Date 8/26/91NAME OF PROPOSED DEVELOPMENT VIDEO VILLAGE INC.

FINAL PLAT
Lot 3, Block 1
Steger Retail Addition
City of Rockwall, Rockwall County, Texas

VIDEO VILLAGE

RE: Site Plan for the Video Village Development

SITE PLAN

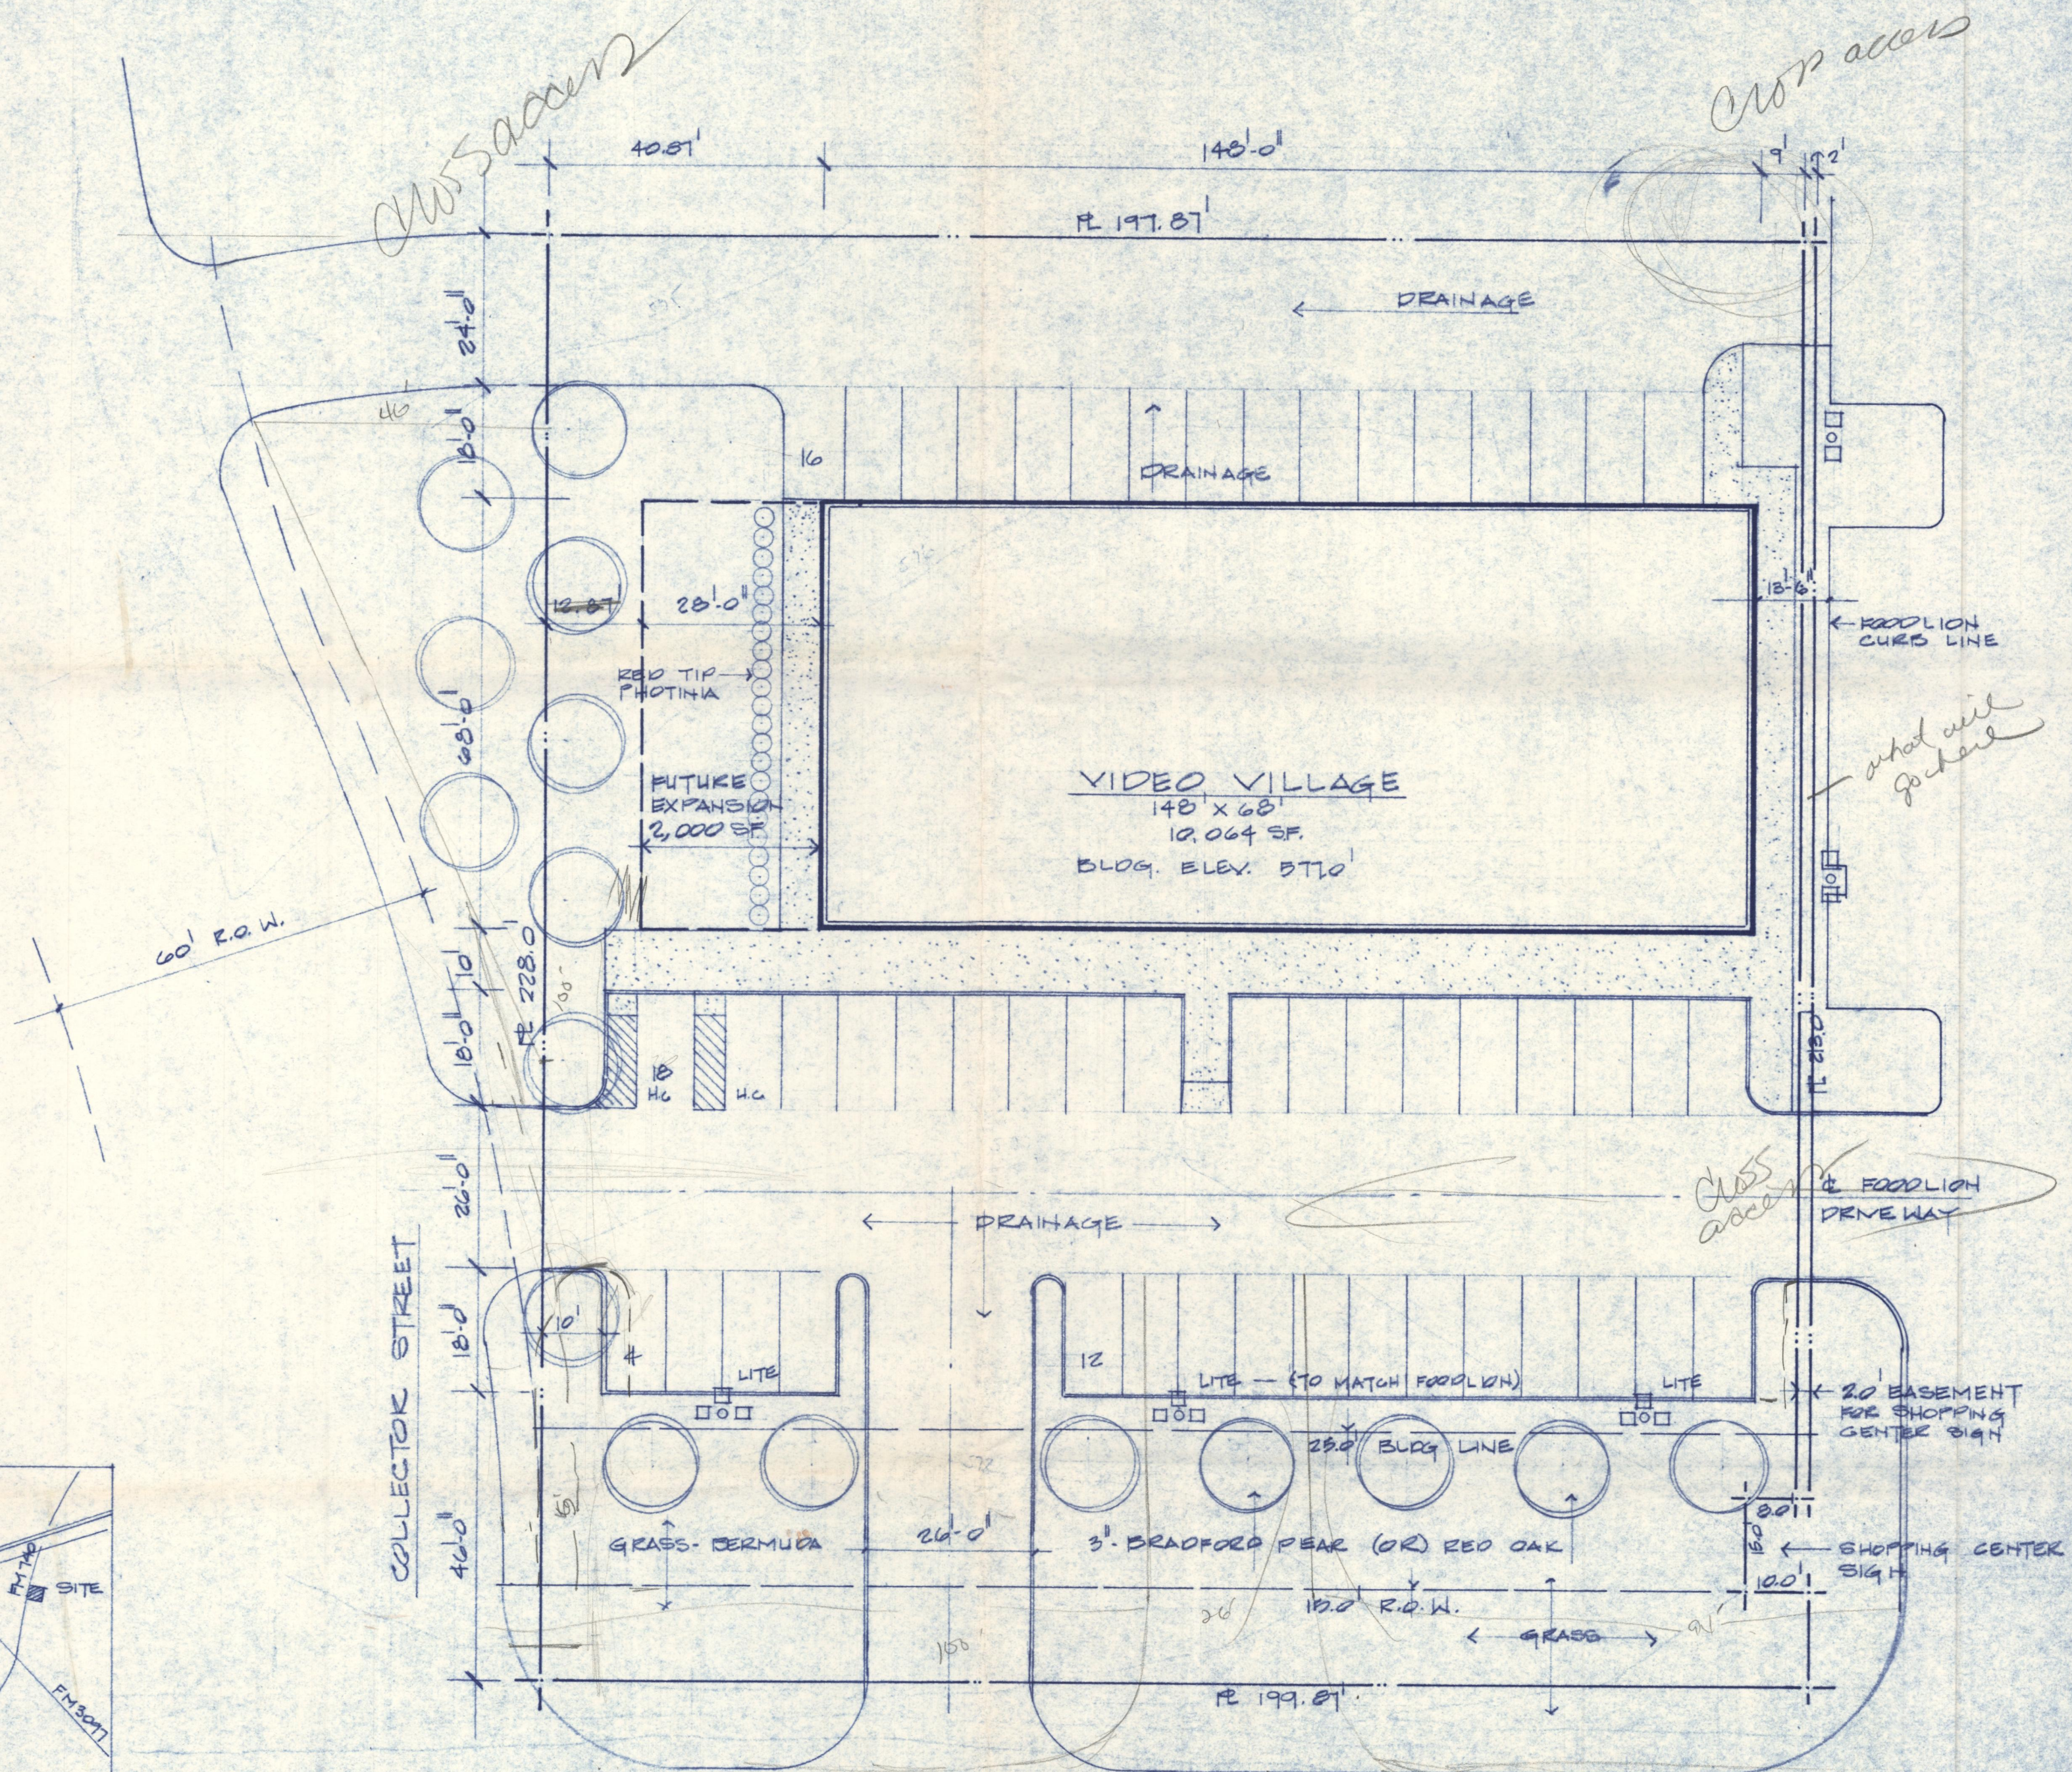
1. The site shows one entrance off of FM-740 and two entrances off of the new collector. We have indicated to the applicant that the entrance off of FM-740 does not meet the 200 foot separation that we normally look for, although this is a separate site from Food Lion. The first entrance off of the collector is 60 feet from the future paving line of FM-740. The applicant had originally proposed a 30 foot distance which concerned staff. We had hoped for a 100 foot setback. We plan to have a recommendation from John Reglin, our traffic planner, by the meeting to address this.

3. The site plan shows a future expansion of 2,000 sq. ft. Parking is not provided for this additional sq. footage and we have asked the applicant to address this issue. The 740 drive would provide several parking spaces if it were removed. We do question the need for this entrance. If the entrance is approved it needs to be moved at least 100 feet from the intersection.

Site Plan - the site plan was unanimously approved with the revised elevations that were submitted to the Commission on Thursday night with the condition that the drive access off of FM-740 be deleted. There was considerable discussion about the drive on FM-740 and whether it is needed. The recommendations from Mr. Reglin also address the drives. A copy of the revised site plan and elevations are attached.

WEST ELEVATION

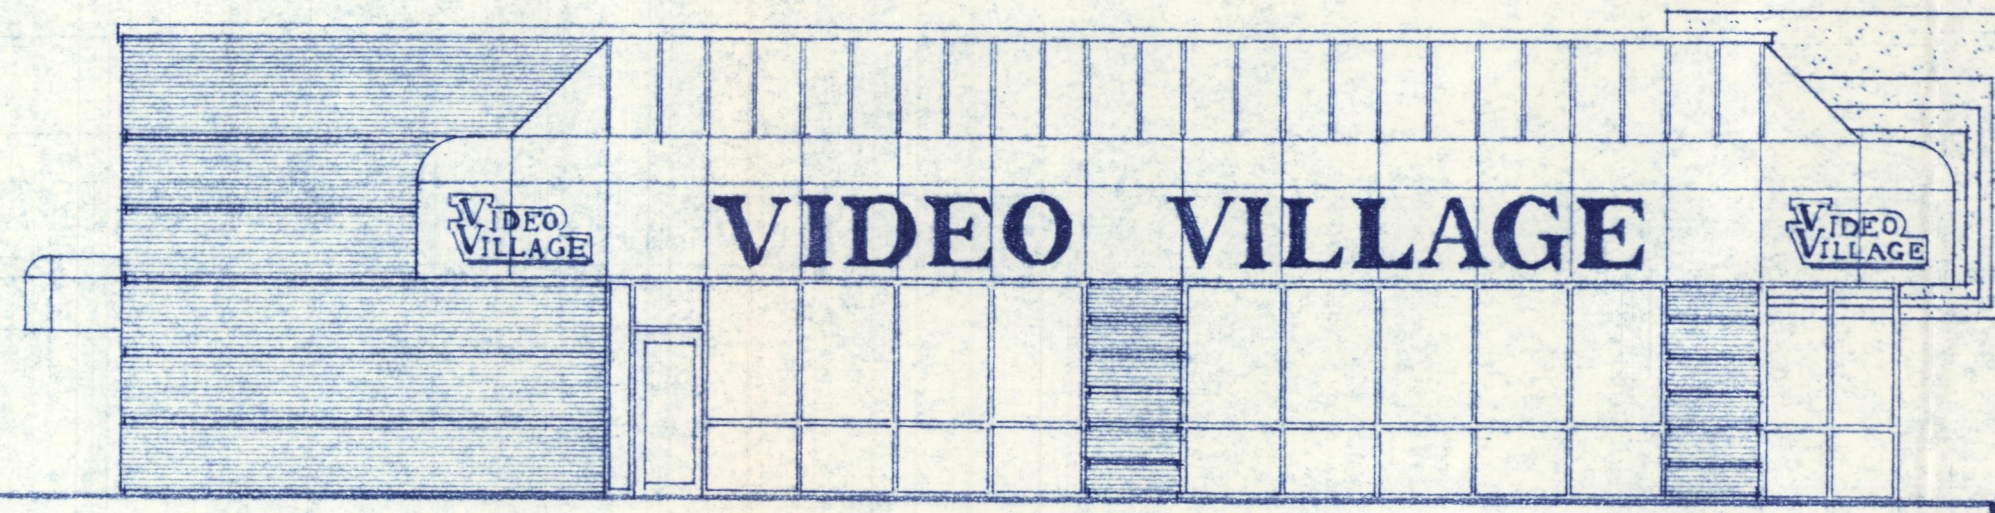
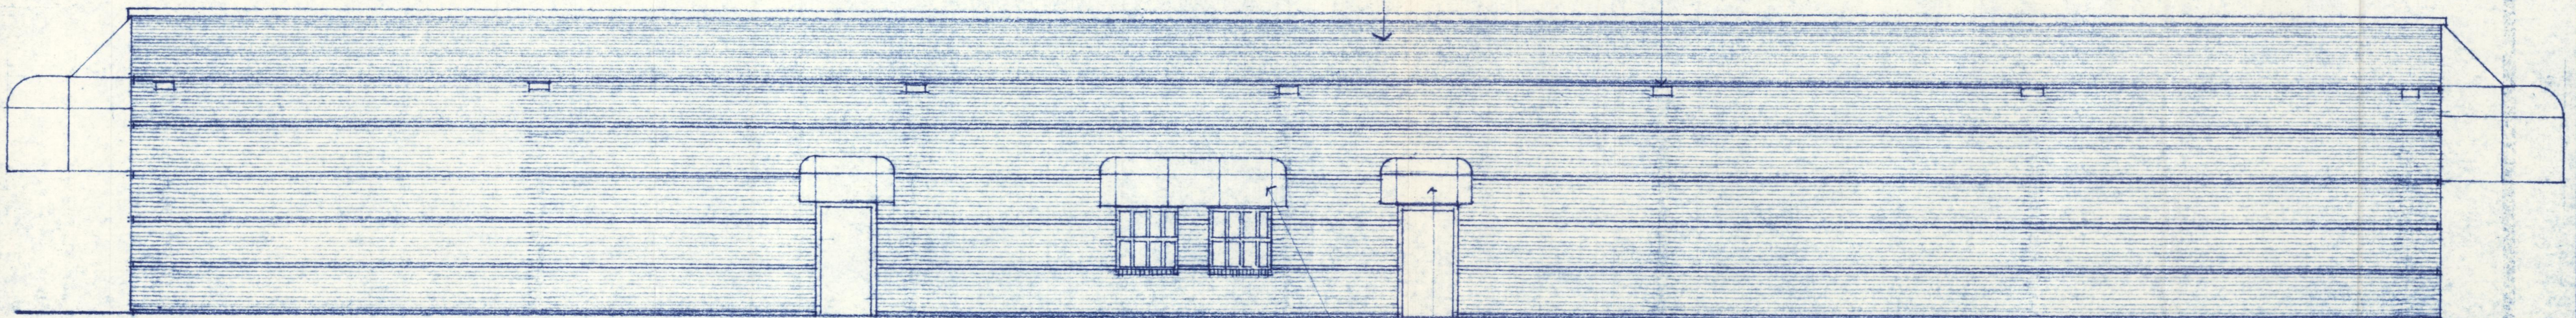
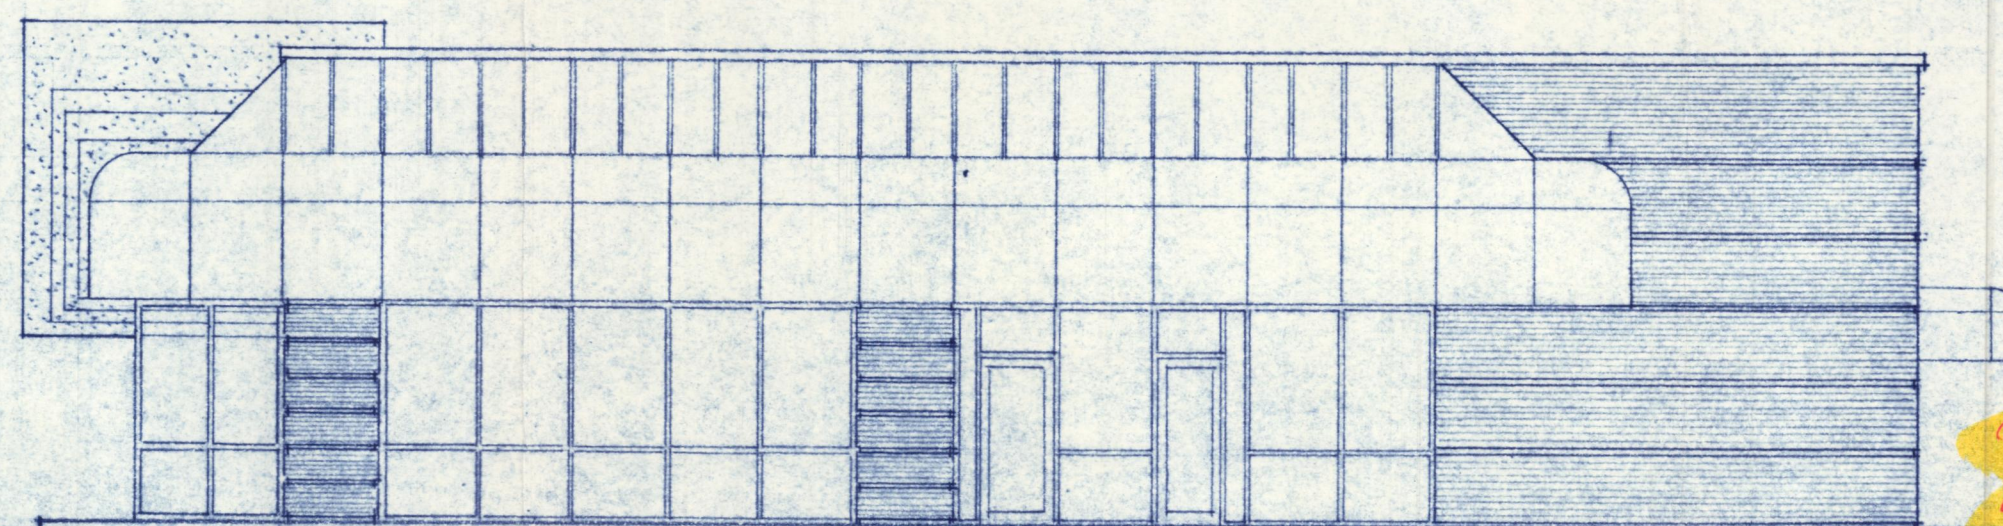
1. The Architectural Review Board has recommended that the back of the building be enhanced with brick work and/or canopies. The applicant will address this item at the meeting on Thursday. They have also recommended that the applicant provide information to ensure that the AC units will not be visible from the street. There is a parapet wall of approximately 4 feet all around the building and the applicant has indicated that this will not be a problem. They have also recommended that the trees be more naturally planted in the street buffer.

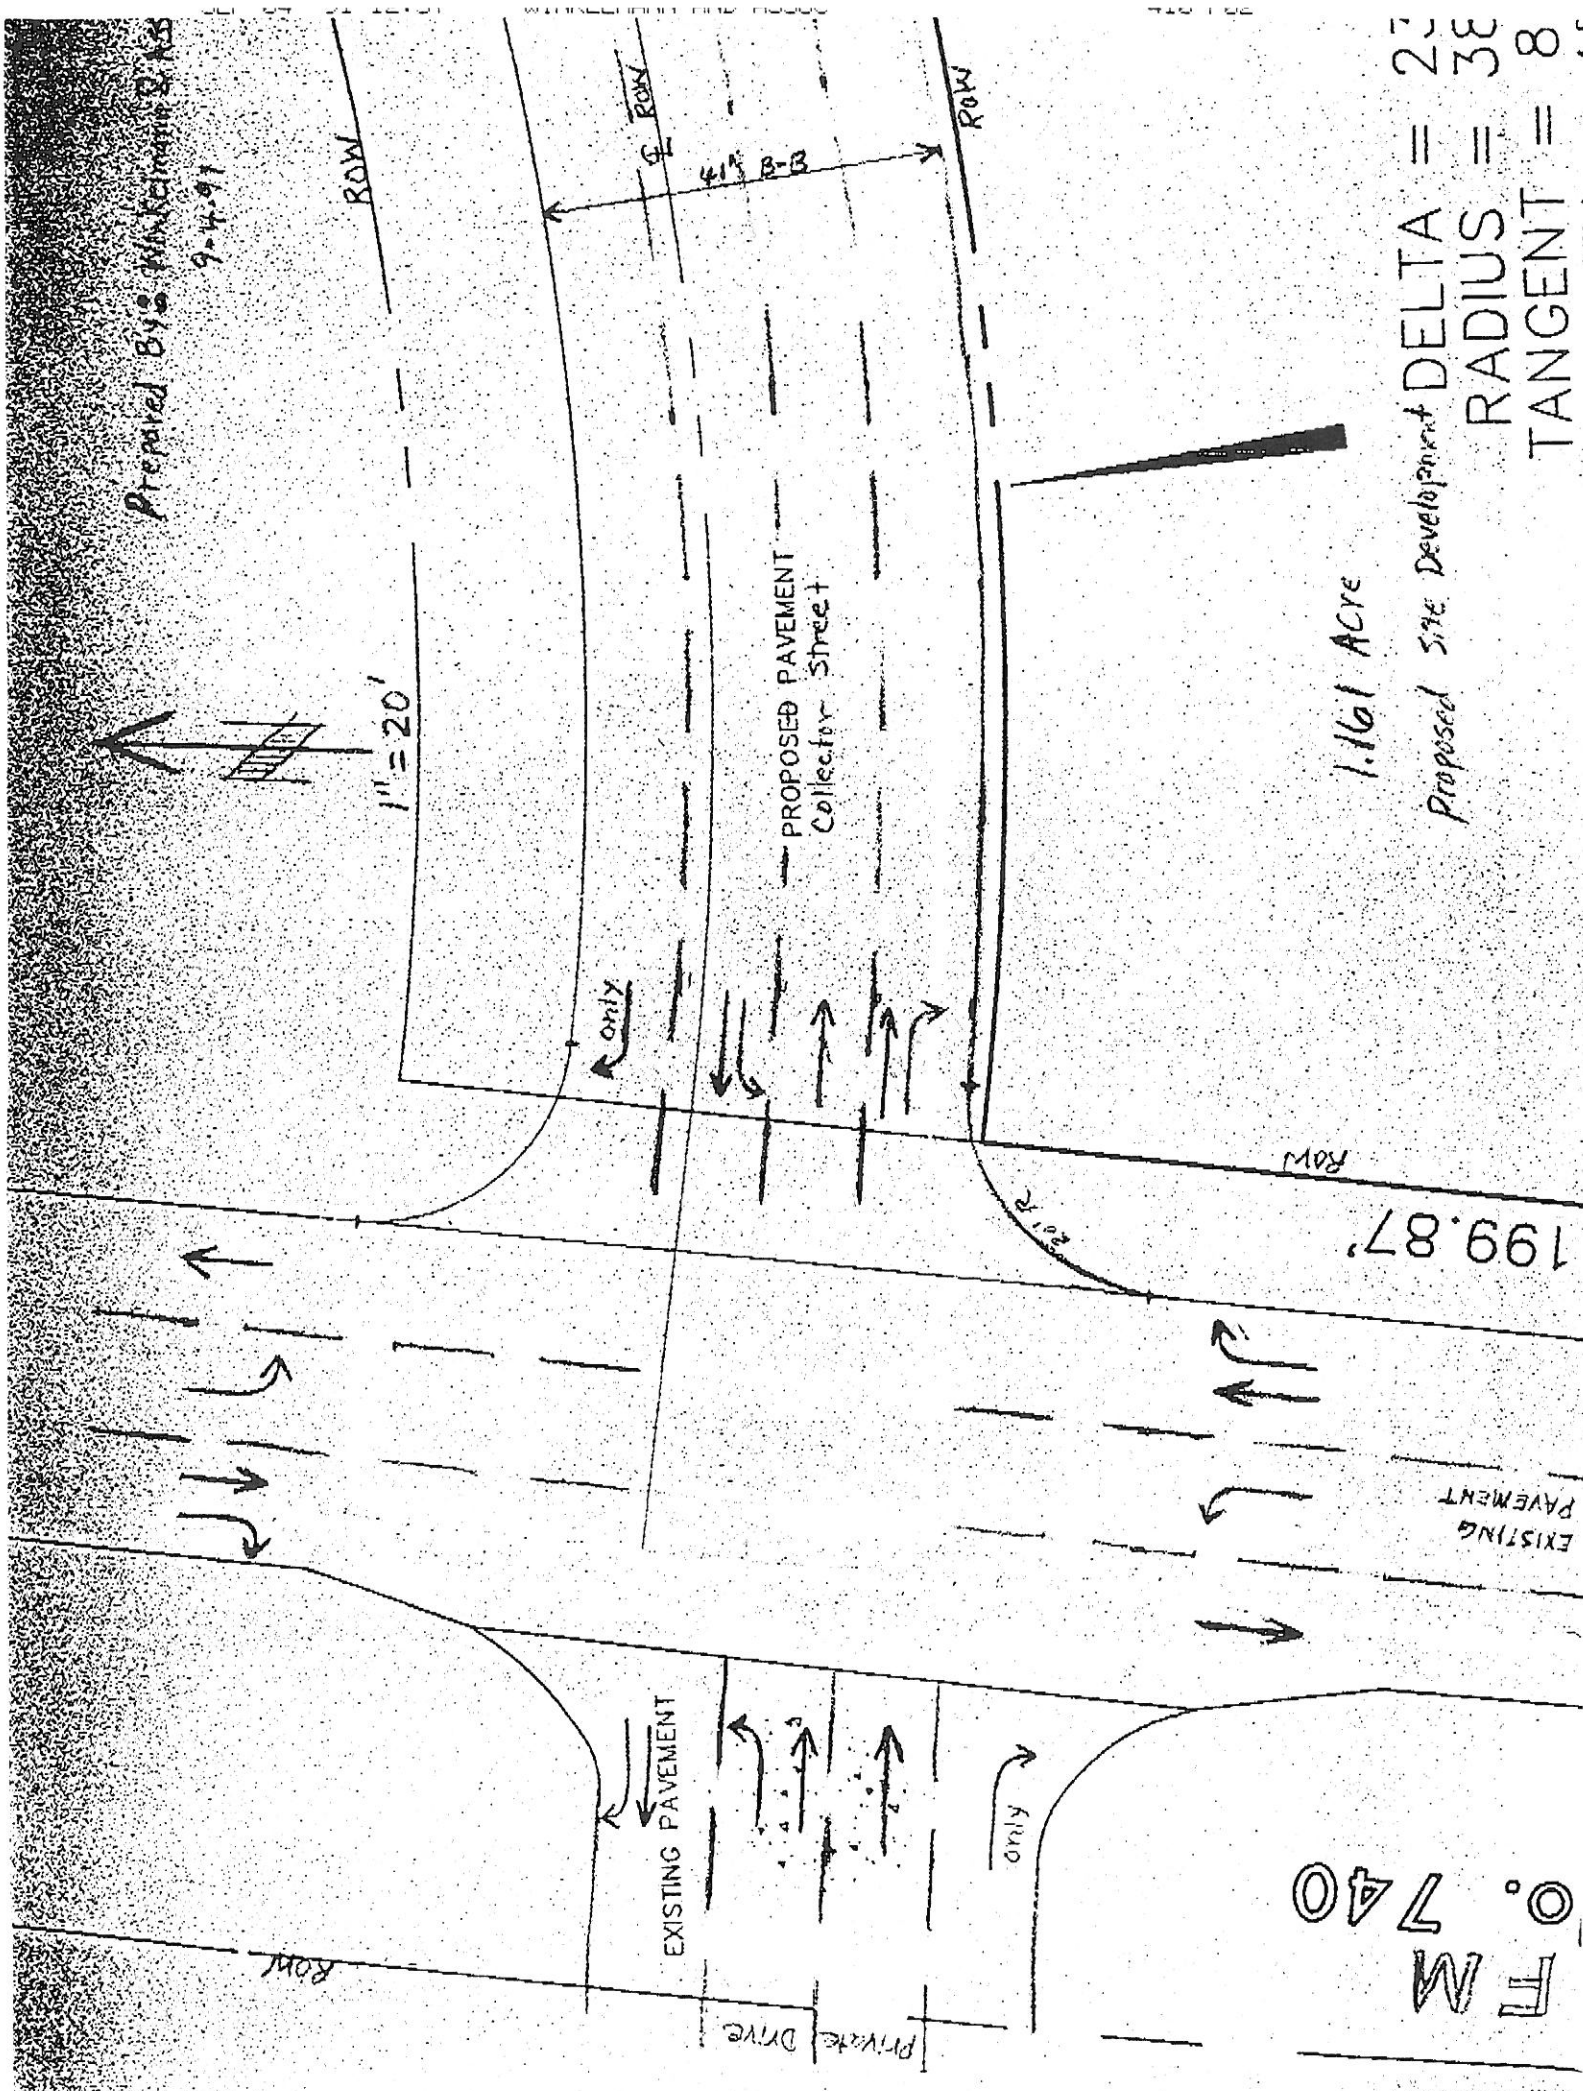
✓ need to show radius on steel enticement 15'
